STEP BY STEP EARLY LEARNING CENTER	EXISTING CONDITIONS
---------------------------------------	---------------------

STEP BY STEP
EARLY LEARNING CENTER
DEMOLITION & TESC PLAN

C3.01

07/09/2024
Date

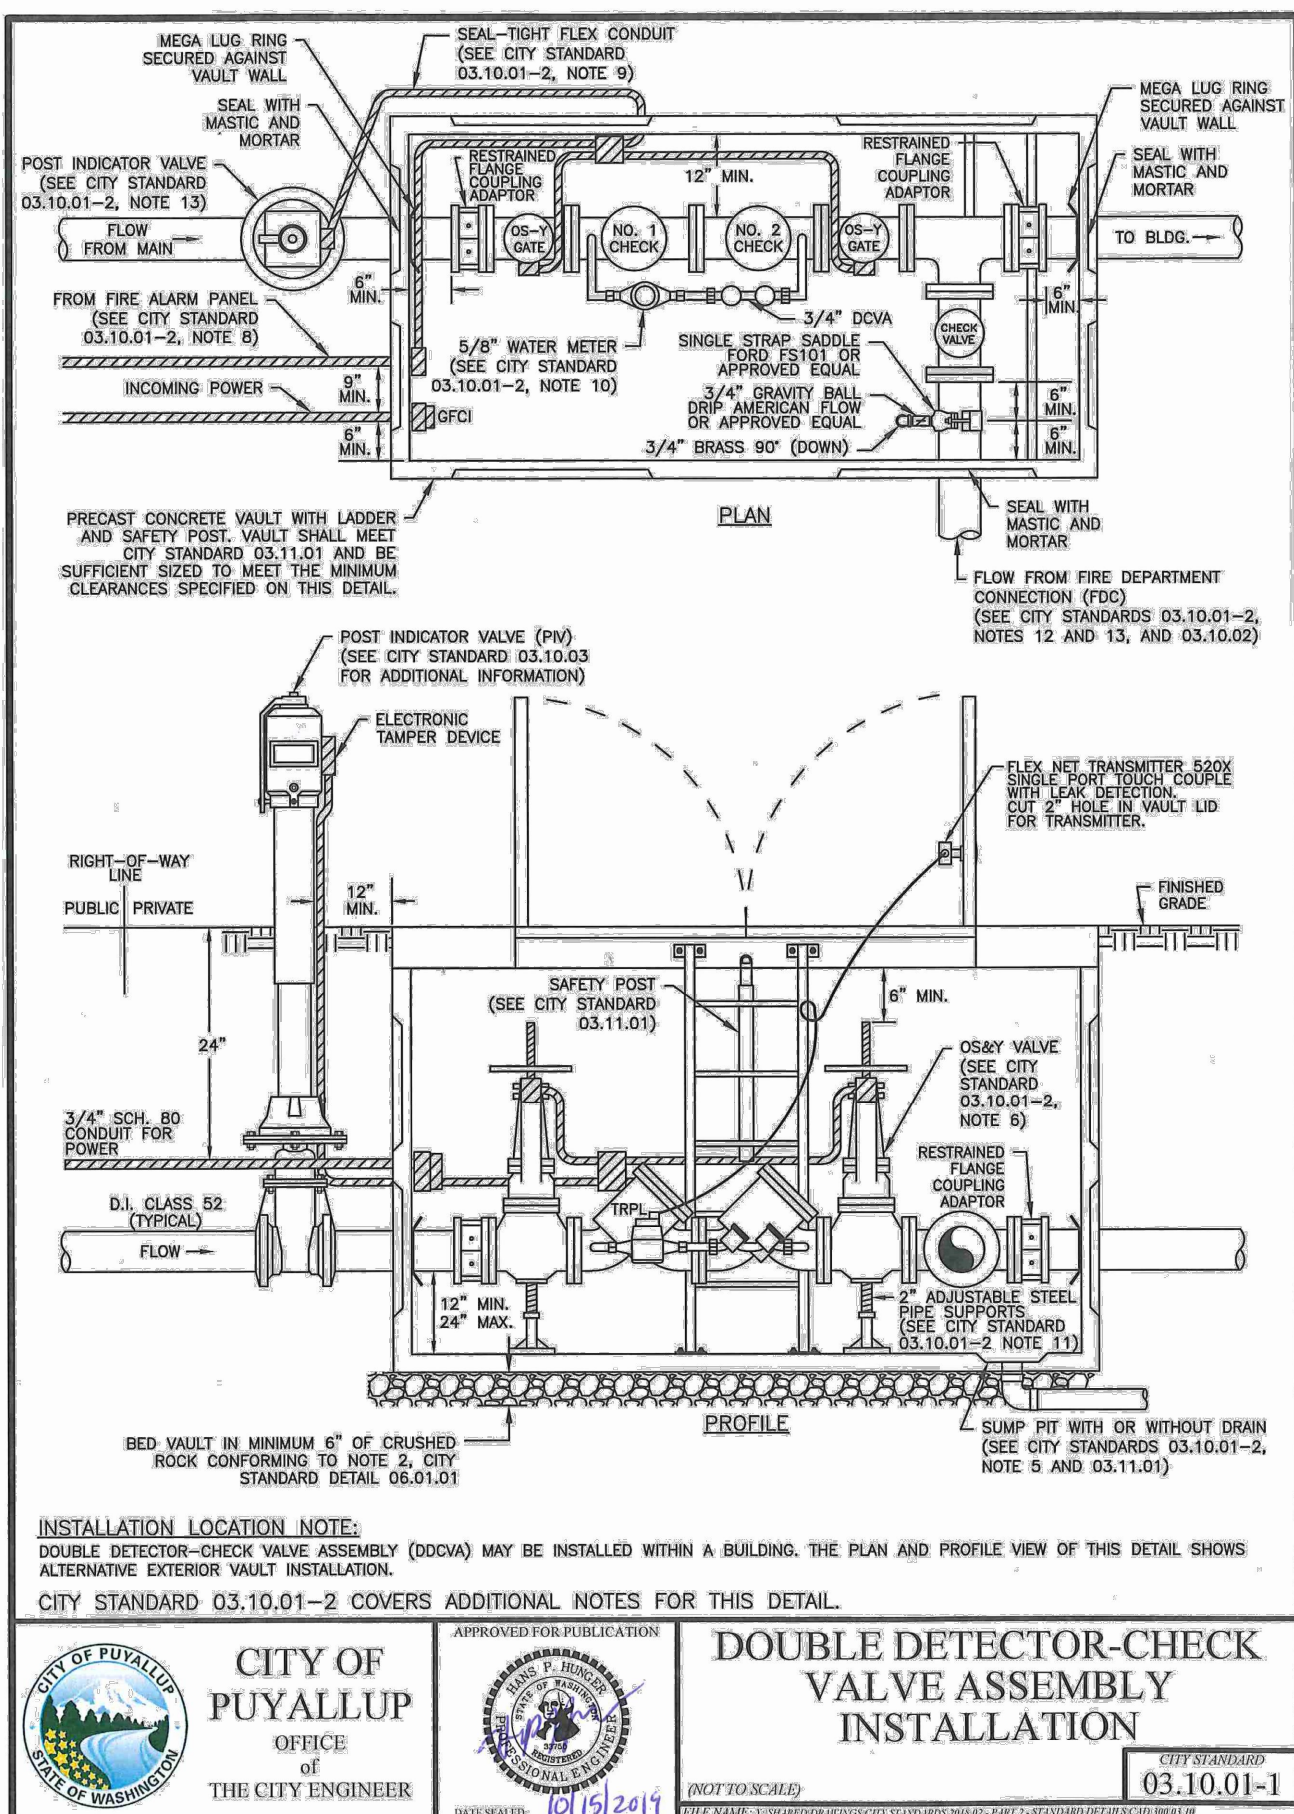
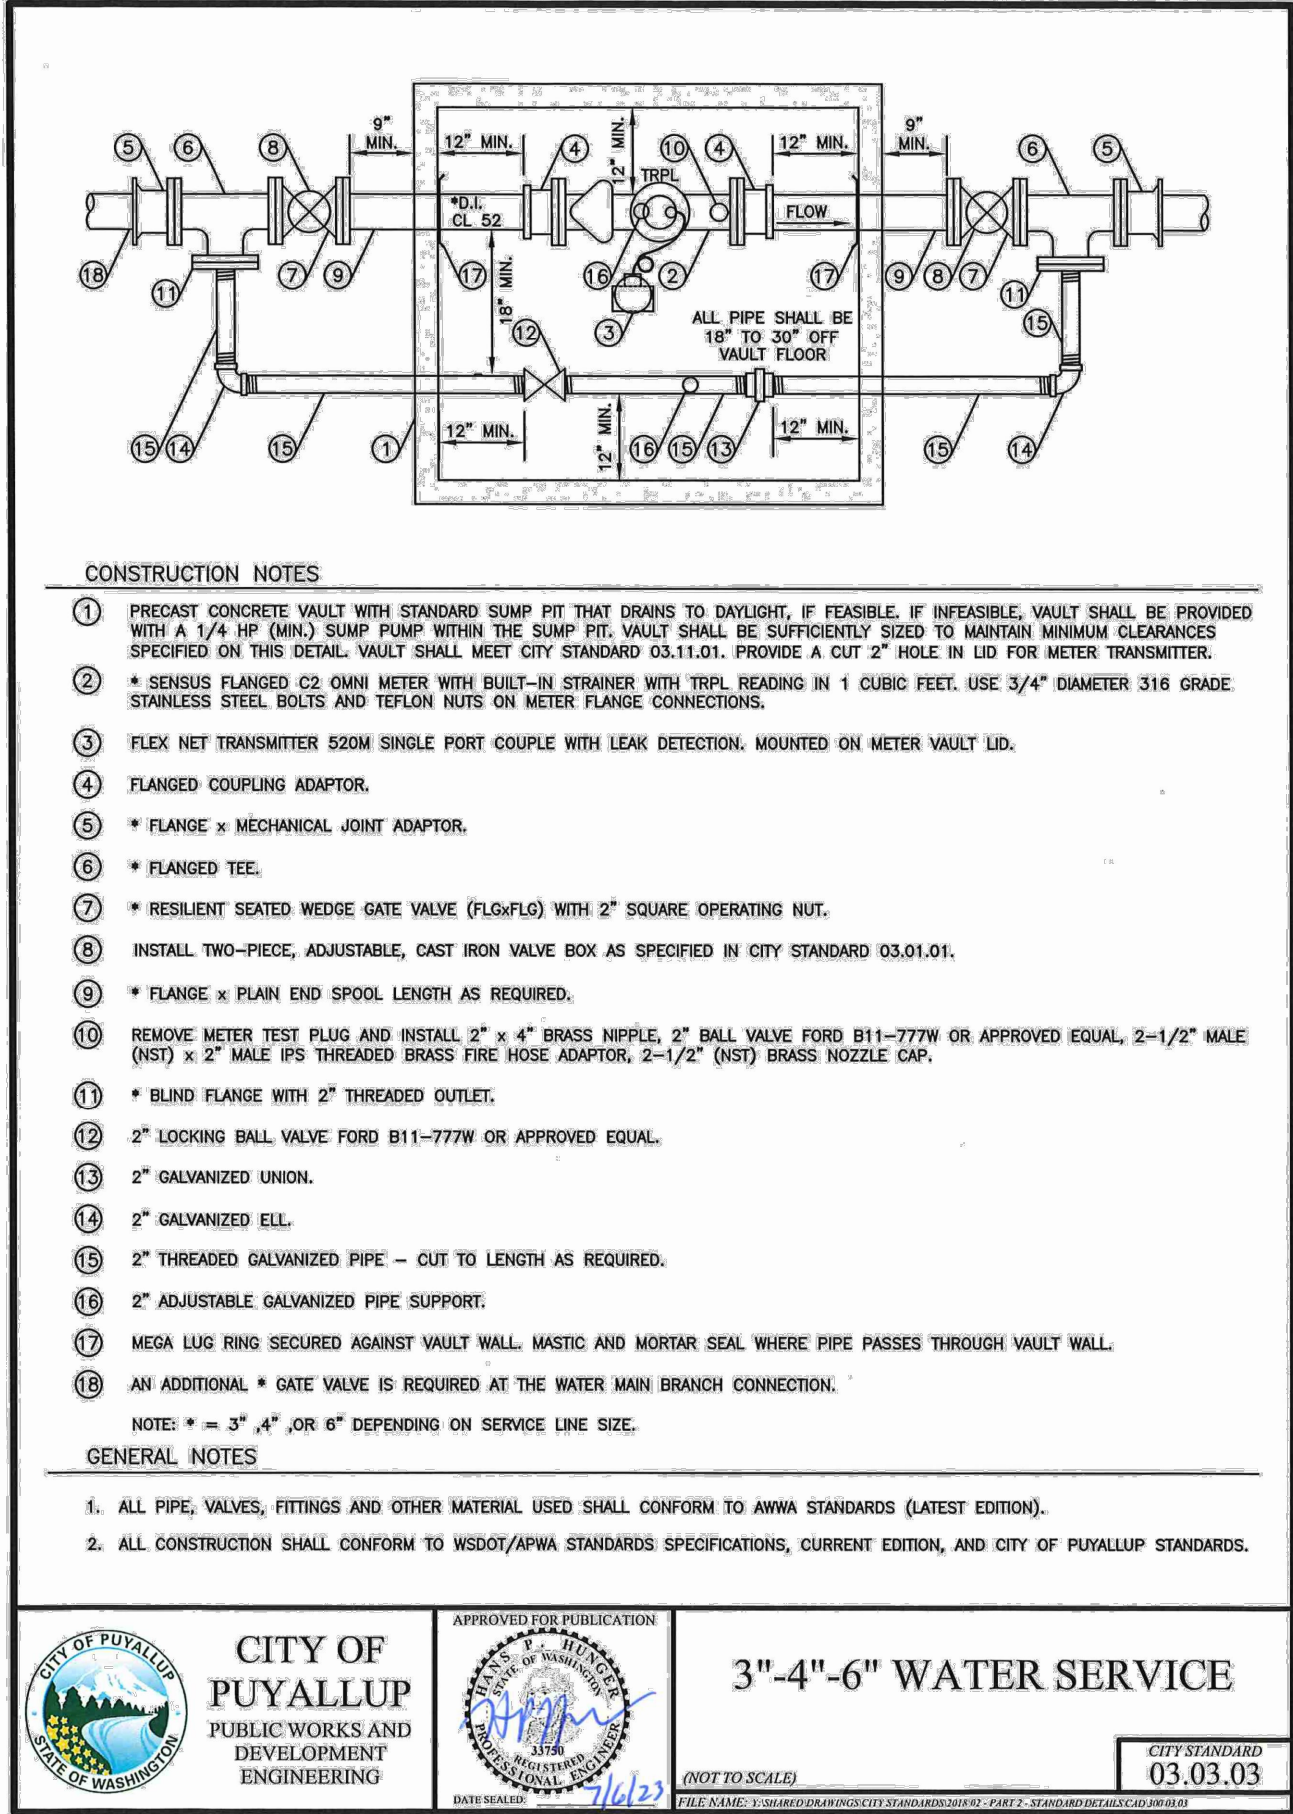
Add City Standard Details:
03.05.01 // 03.11.01 // 04.03.05 //
[Plans; Sheet C6.10]

Details have been added.
